Chesapeake modifications to Regional Standards Third Edition

DESIGN AND CONSTRUCTION STANDARDS
MANUAL AIR VENT ASSEMBLY

WS_03

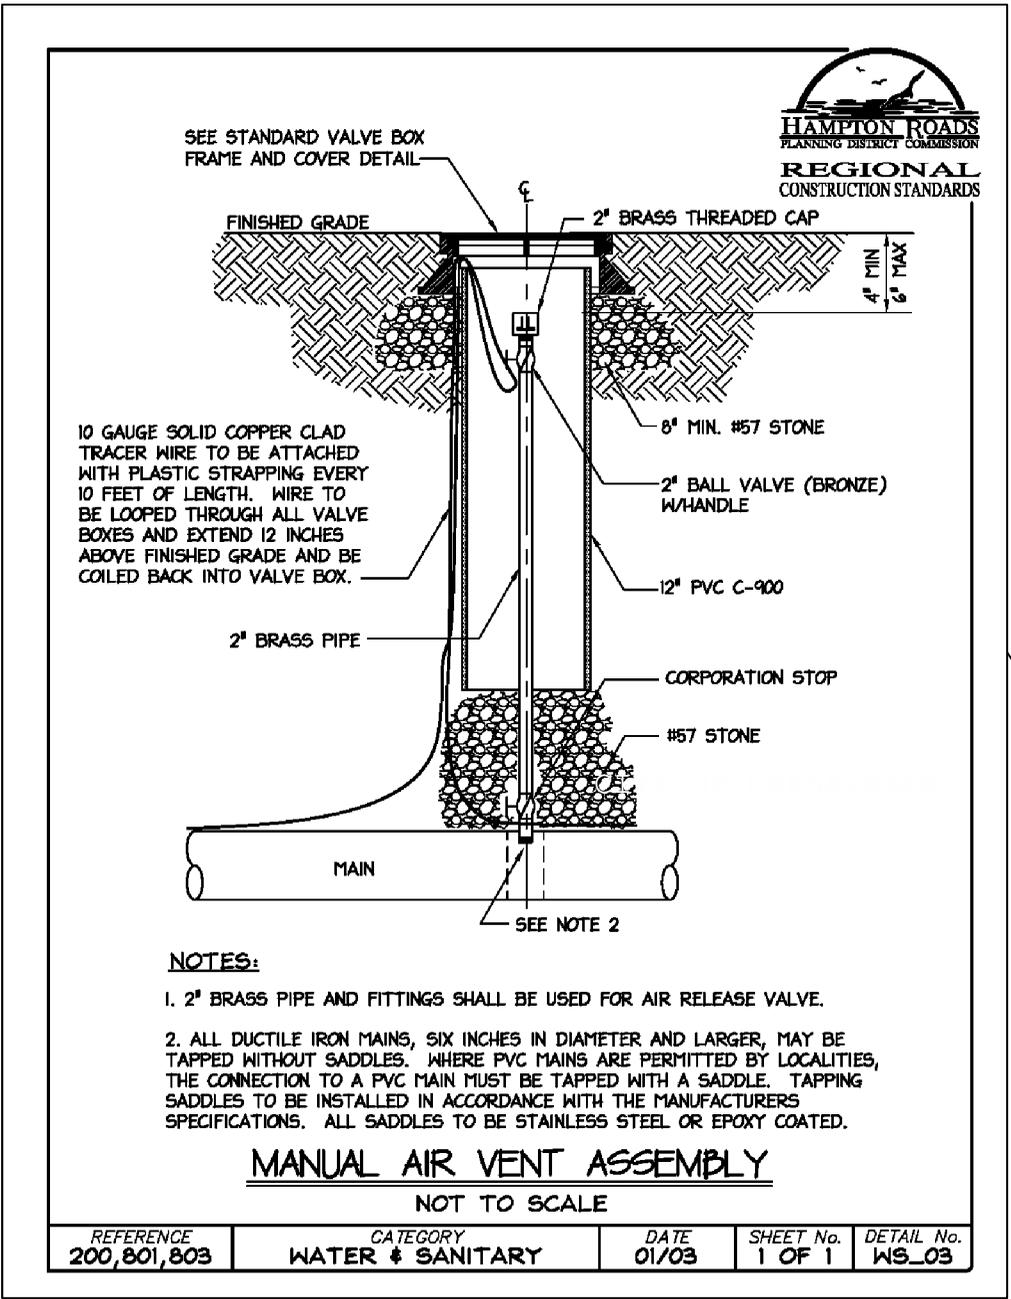
1. An 8" gap shall be provided between the main and the bottom of the riser pipe.
2. Two bricks are to be placed under the riser pipe for the valve to provide support.
3. Replace the #57 stone with sand.
4. A two inch corporation stop shall be used to make the connection to the pipe.
5. Replace the #57 stone under the valve box frame with #26A stone.
6. The air vent pipe shall be set plumb.
7. All ductile iron mains and PVC mains 6" and larger must be tapped without a tapping saddle. Tapping saddles are required for taps on 4" PVC mains and must conform to the specifications
